SPRUCE RUN DAM

PHASE I INSPECTION REPORT
NATIONAL DAM SAFETY PROGRAM

NJ 00132

DEPARTMENT OF THE ARMY
PHILADELPHIA DISTRICT, CORPS OF ENGINEERS
CUSTOM HOUSE - 2D & CHESTNUT STREETS
PHILADELPHIA, PENNSYLVANIA 19106
25 APRIL 1978

Photo 1 - 12 December 1977

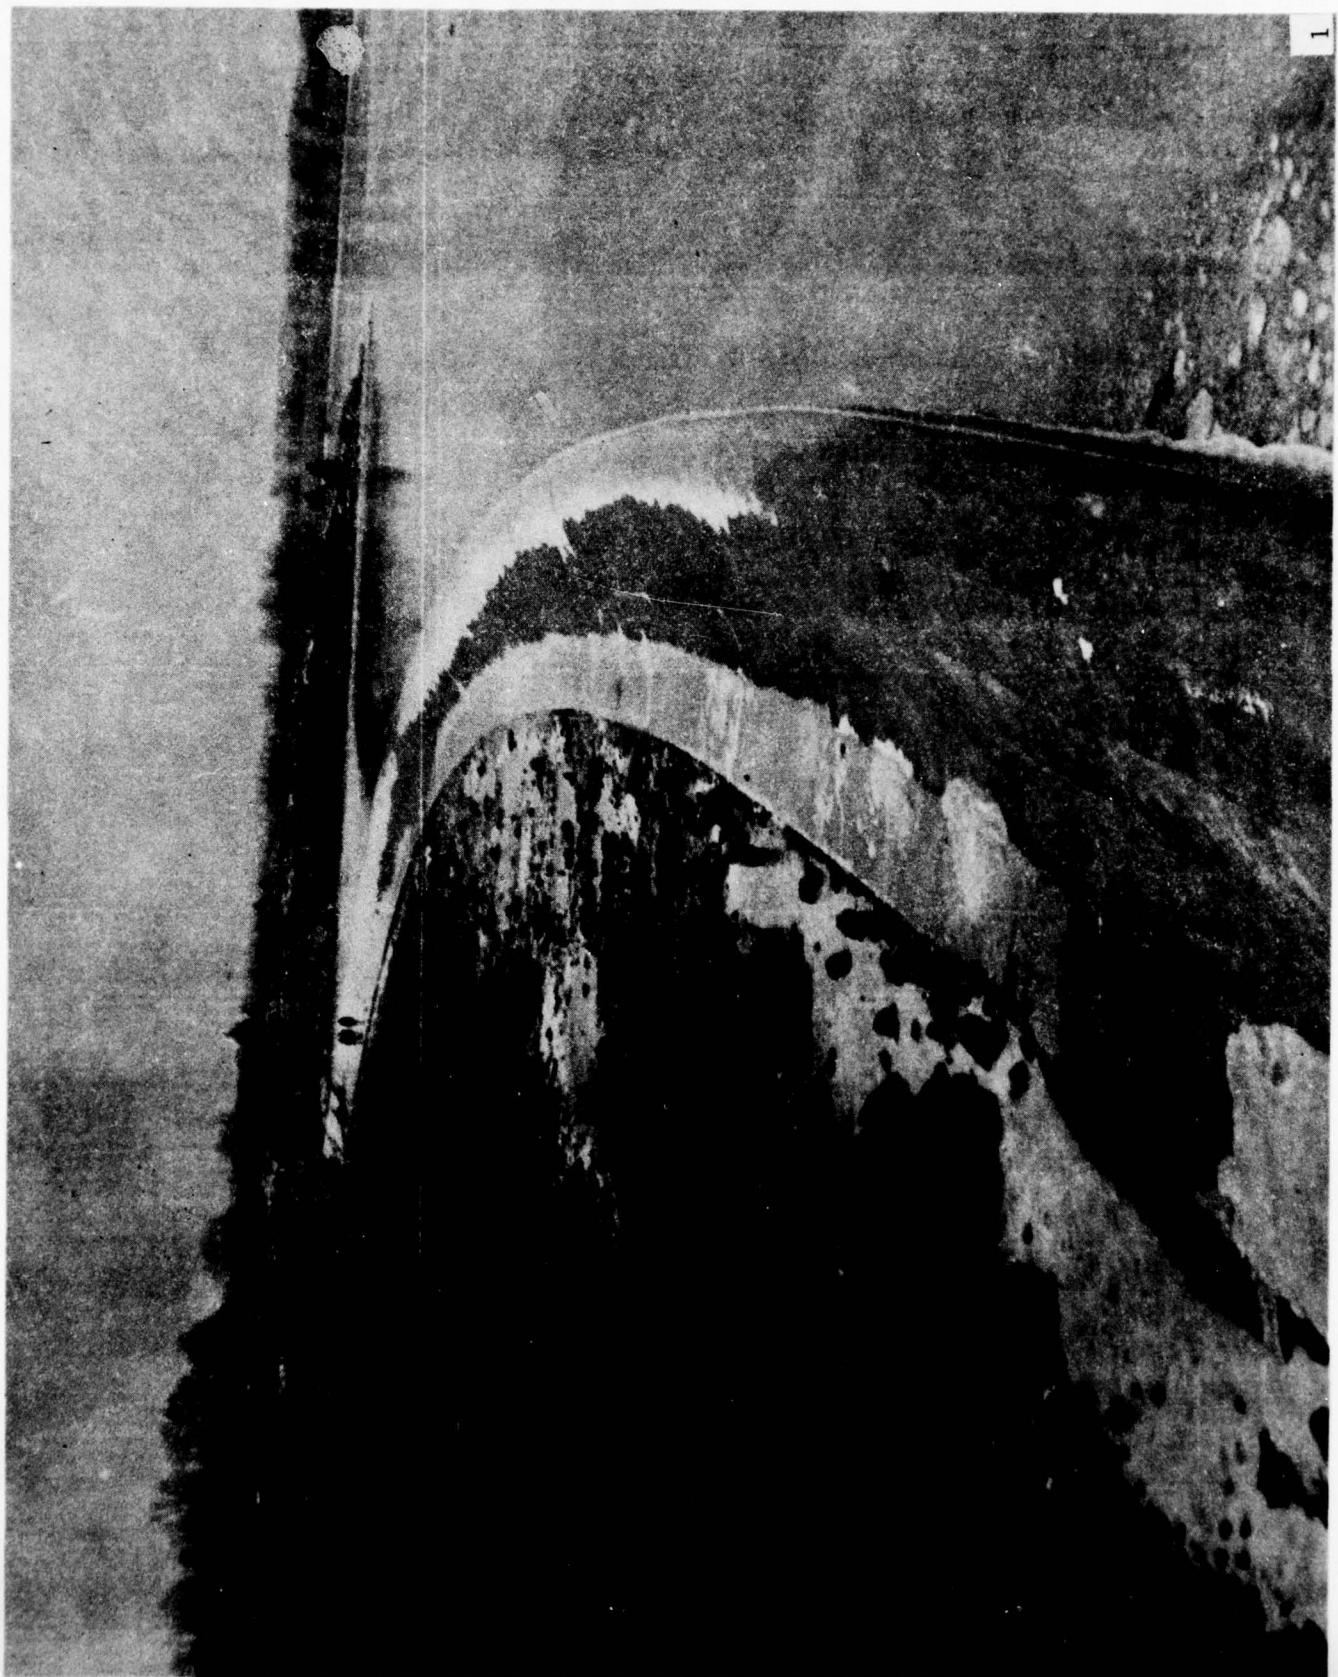
Overview of concrete ogee weir structure looking southward from left spillway abutment towards right spillway abutment

Photo 2 - 12 December 1977

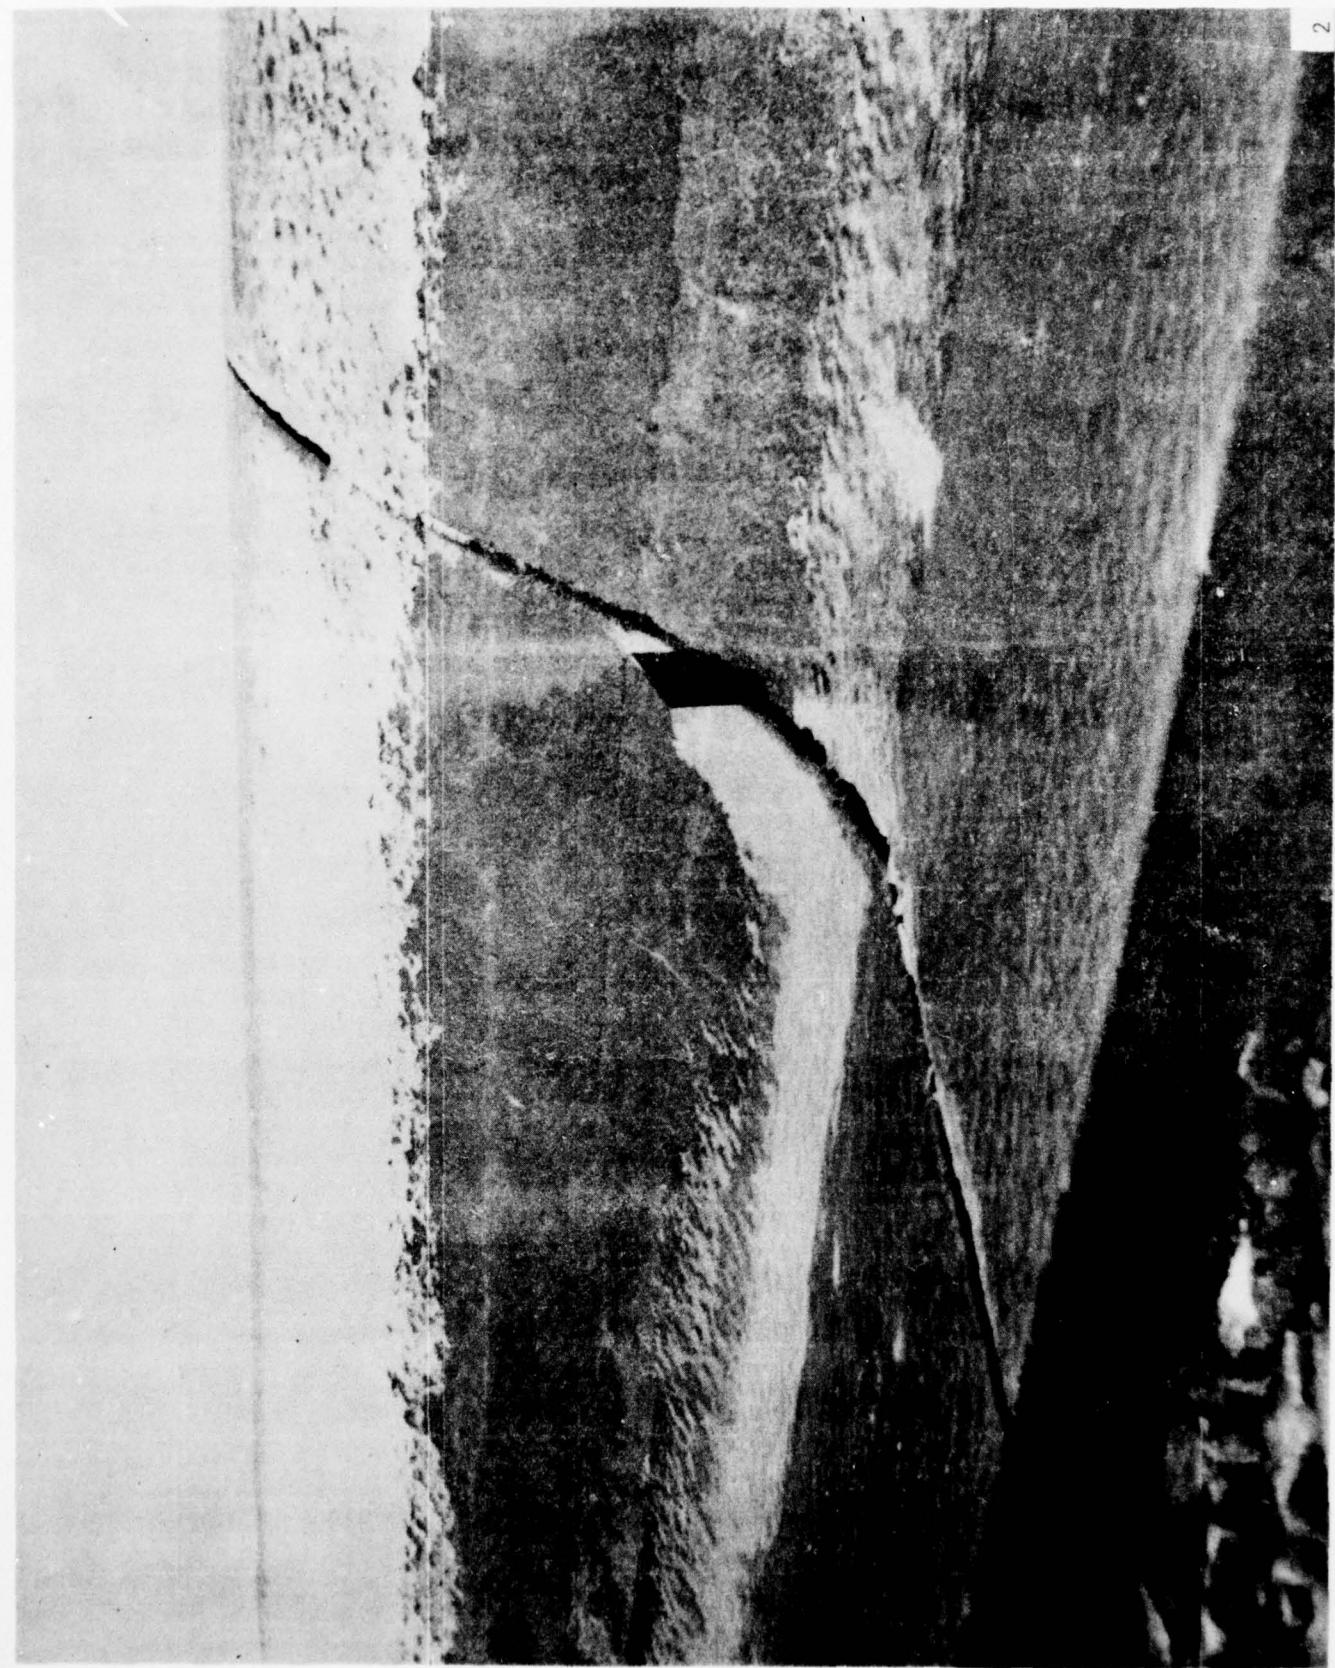
View of typical joint of concrete ogee weir indicating open joint and loss of joint filler.

Photo 3 - 12 December 1977

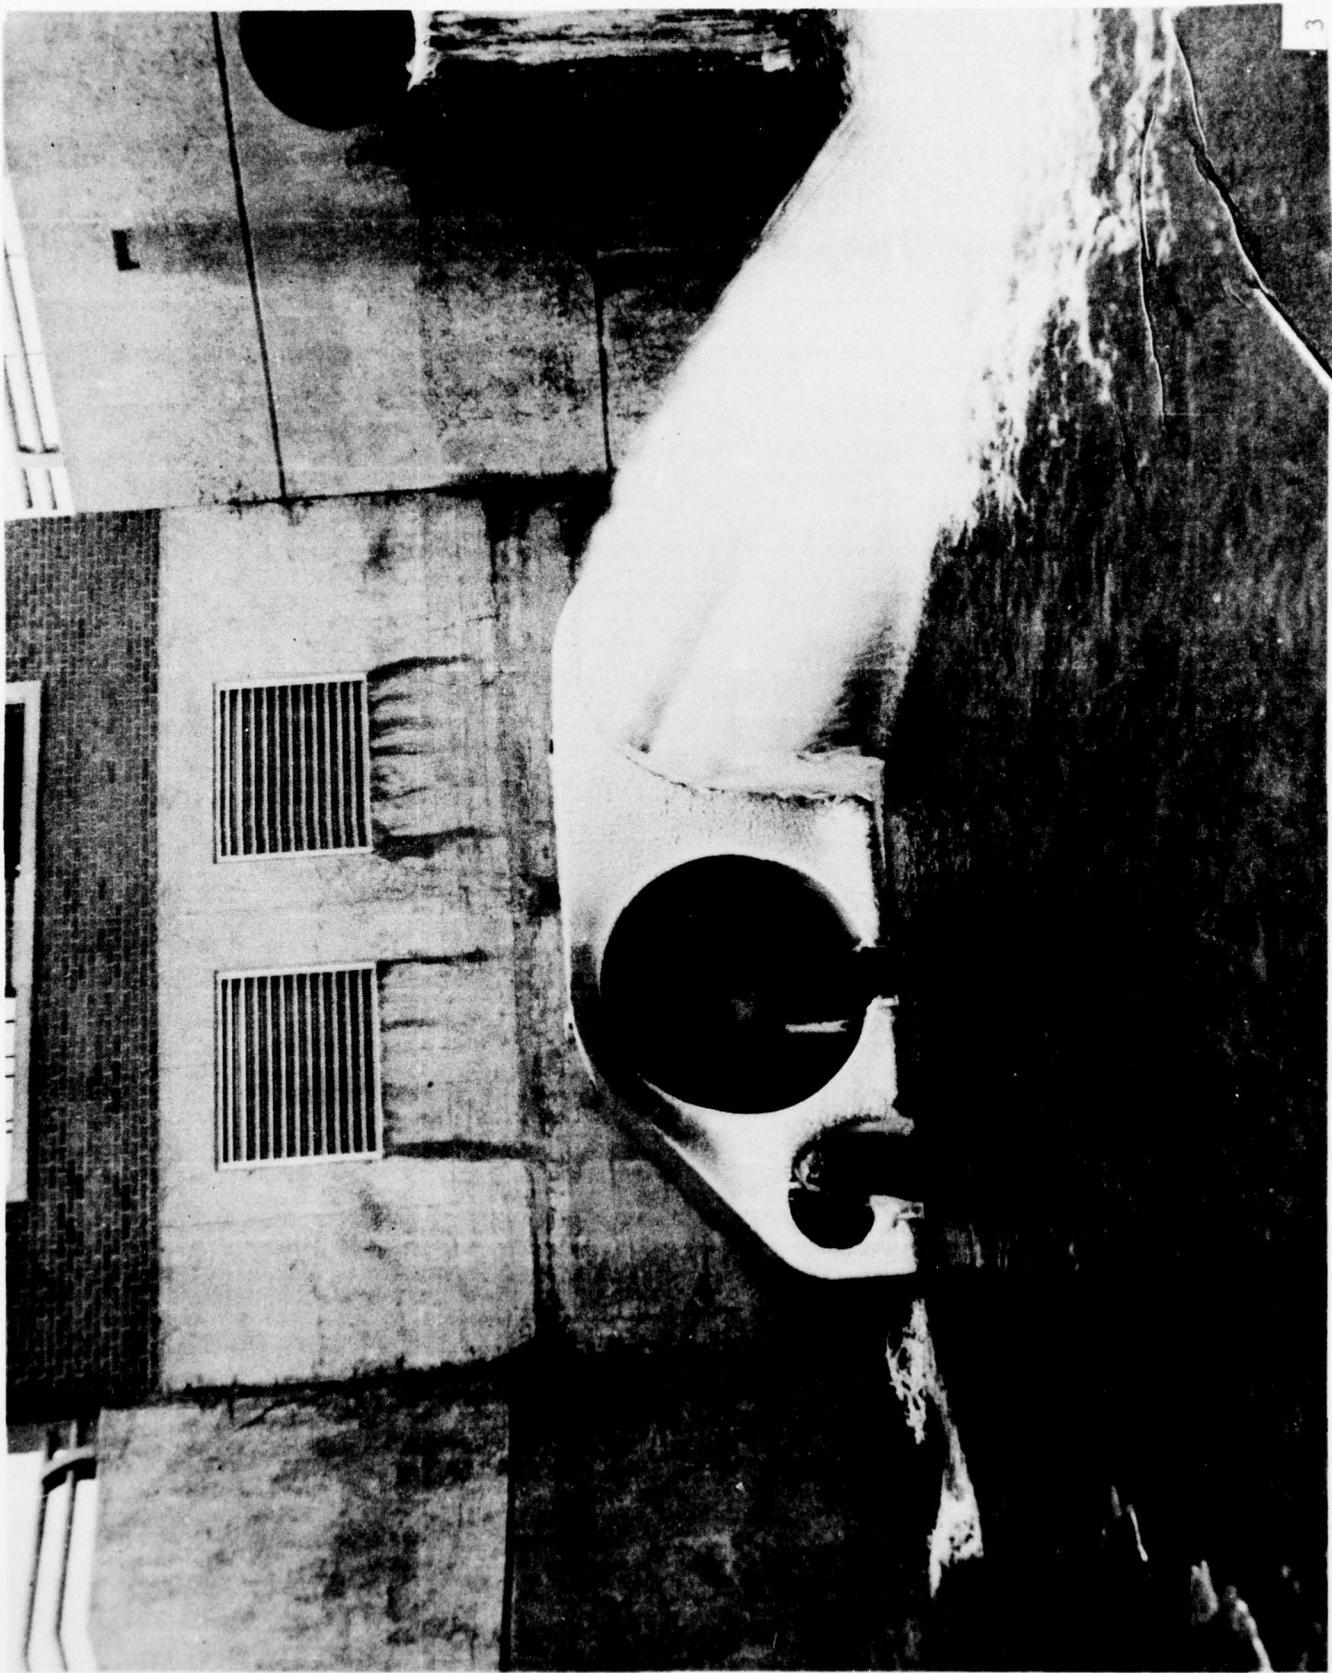
View of two 30" venturi outlets with conical regulating devices, one of which is operational.
